**RE: Existence of a Roll-Up Door Constitutes a Garage
2018 NCRC Section R302.5 and R302.6**

This letter is in response to your request for formal interpretation dated January 19, 2021 that was received in NCDOI by email on that same date. Your request for formal interpretation, in my words, states:

Does converting an exterior door opening from double swinging doors (French doors) to a roll-up door that is large enough for an automobile qualify the space as a “garage” and require compliance with Section R302.5 and R302.6 of the 2018 NC Residential Code (NCRC)?

ATTACHMENT B
(As-Built)

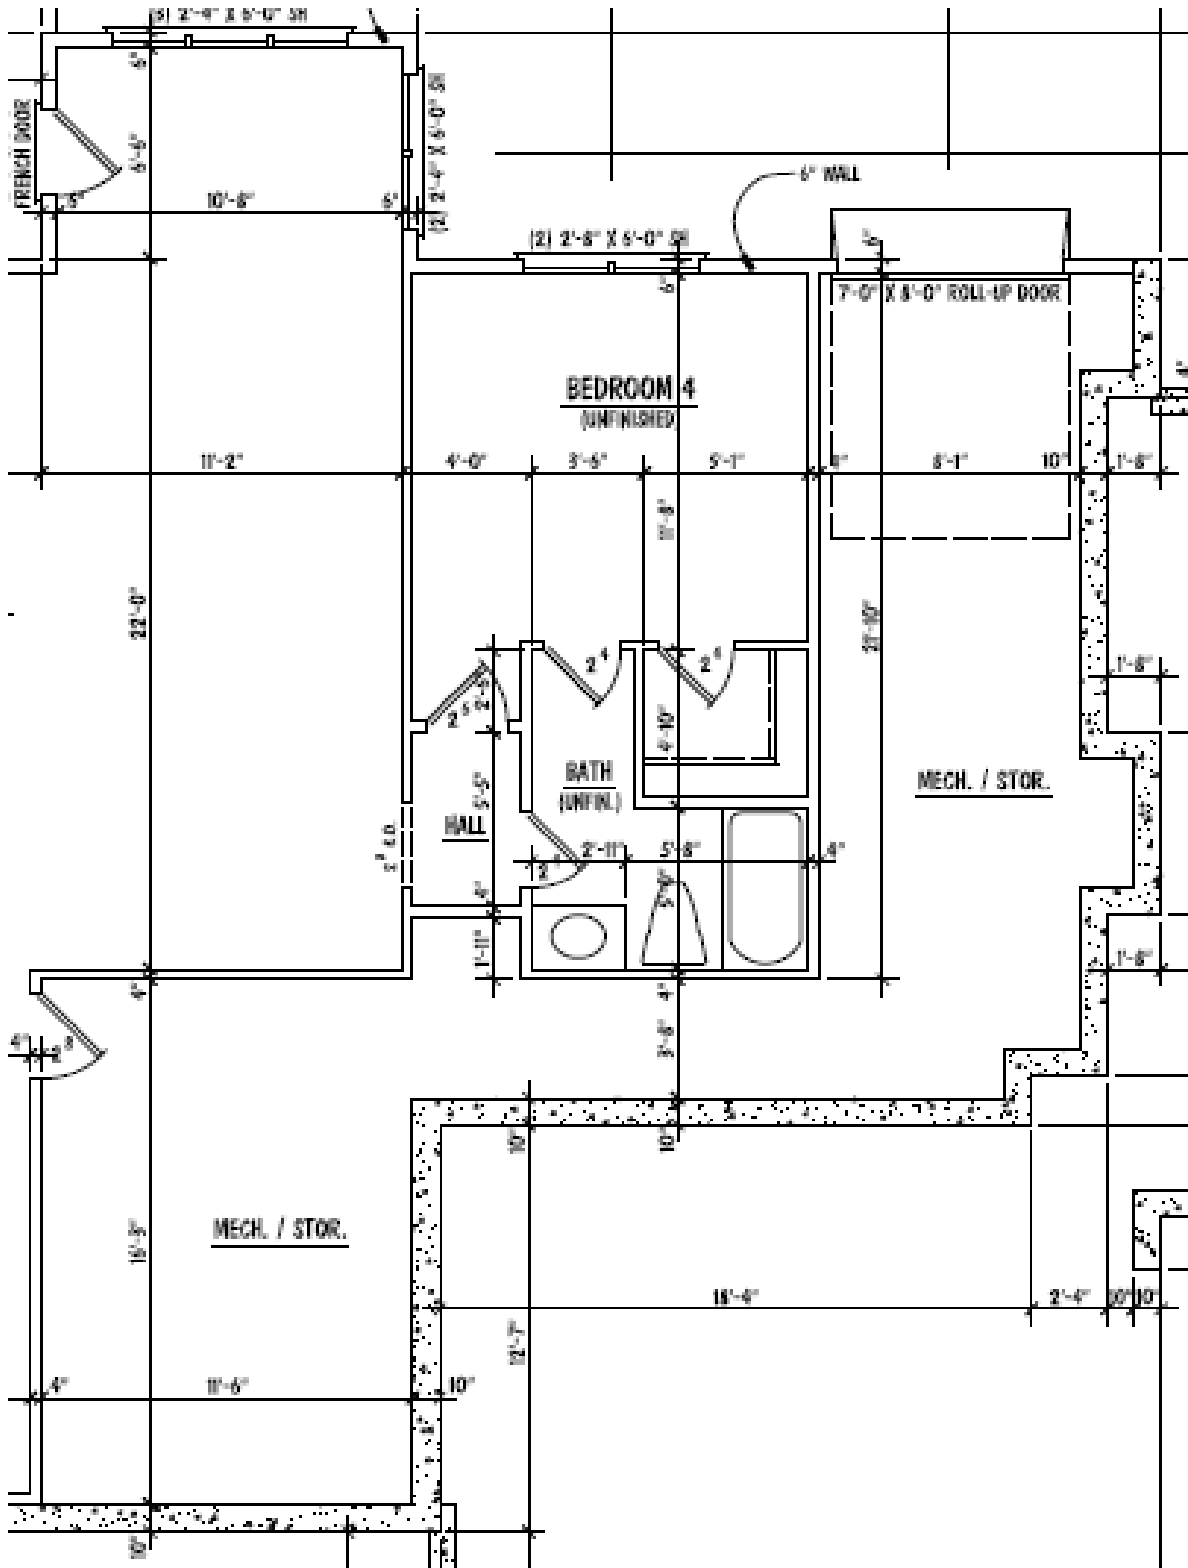
The plans provided with this request for formal interpretation do not match those provided for the informal interpretation in that the space in question is wider on the later plans than on the informal interpretation request plans (see Attachments B and C). The space is now 8’-1” wide with a 7’-0” wide door. The original informal request showed a 7’-4” wide space with 5’-4” wide double swinging doors.

We are requesting a formal interpretation in regard to the mechanical/storage area in question of the provided as built plan. During construction we swapped out the exterior double french doors to a 8' x 7' roll up style door. It was determined by the town of Fuquay that by simply swapping the style of the door constitutes a change of the proposed space. Their stance on the matter was that this mechanical/storage space was now a "garage". And would have to be brought up to code to be considered a separated grage.

The attached plans indicate that the space is for mechanical equipment and storage and appears to be too narrow (7'-4") for a car or truck to be accessed if they were driven inside the space.

While the space might be used for storage of self-propelled lawn equipment or flammable liquids or materials by the homeowner, it is not the purpose of Section R302.6 to address such use; therefore, I would determine that Section R302.6 does not apply to the space shown in the attached basement plan labelled as "Mech/Stor" and now accessed by a roll-up door as shown in the attached photograph.

The installation of a roll-up door does not in itself determine whether a space is considered a garage. The code also does not stipulate that the room name provided on a set of plans determines whether a space is considered a garage. Based on the above code analysis the purpose of the space determines whether it is a garage. If “self-propelled vehicles” such as, but not limited to, cars, trucks, motorcycles, riding lawn equipment, golf carts, boats, and yard, garden, or farm tractors are stored or serviced in a space the code considers the space a “garage” and compliance with Sections R302.5 and R302.6 is required as well as Section R309.

REAR ELEVATION

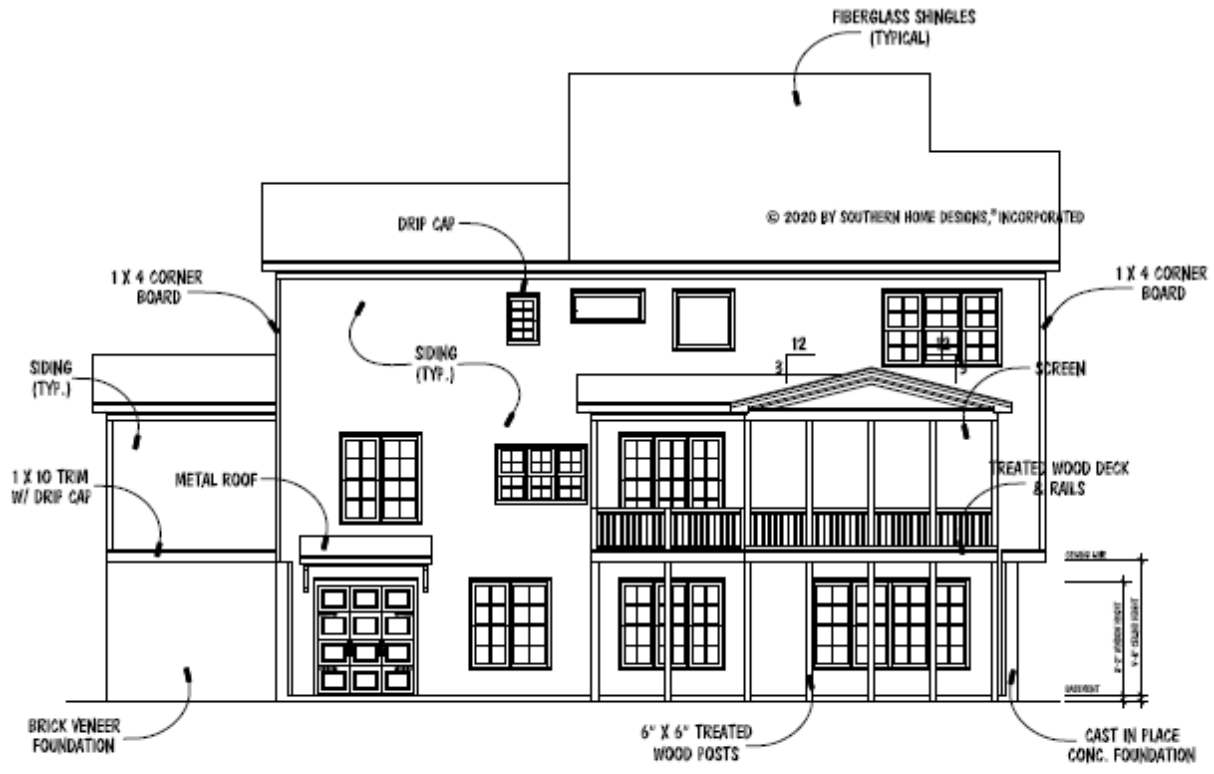
There is no drive connecting the roll-up door to a street and it does not appear that such a connection would likely ever be provided.
